United States Patent and Trademark Office

PPLICATION NO.	LICATION NO. FILING DATE		FIRST NAMED INVENTOR	ATTORNEY DOCKET NO.	CONFIRMATION NO.
09/809,074	0	3/16/2001	Shinya Nagamatsu	204842US-8 5550	
22850	7590	06/25/2002			
OBLON SPIVAK MCCLELLAND MAIER & NEUSTADT PC FOURTH FLOOR 1755 JEFFERSON DAVIS HIGHWAY				EXAMINER	
				LEUNG, QUYEN PHAN	
ARLINGTO	ON, VA 22	2202		ART UNIT PAPER NUMBER	
				2828	<u></u> <u></u>
				DATE MAILED: 06/25/2002

DETAILED ACTION

【図1】

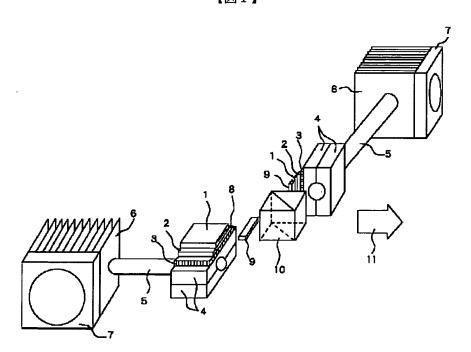
3. Claims 1, 12 are rejected under 35 U.S.C. 102(b) as being anticipated by Imai et al (JP 05-167143A). Imai discloses the claimed invention. Note figure 1 which

illustrates a light source comprising a plurality of densely placed laser diode modules (1), each of the modules (1) having an output of at least 100mW (see abstract which teaches each laser module (1) having an output of 10W).

- 5. Claims 2-11 and 13 are rejected under 35 U.S.C. 103(a) as being unpatentable over Imai (JP 5-167143). Imai discloses the claimed invention except for the metal substrate (2) also mounting an optical component (9). Note Imai shows a light source comprising at least one laser diode module including a metal substrate (2) mounting a

laser diode chip (1), an optical component (9), a peltier device (3) thermally connected with the metal substrate (2), and a heat pipe (5) having a heat absorbing portion (4) and a heat radiating portion (6), the heat absorbing portion (4) of the heat pipe (5) being thermally connected with the peltier device (3).
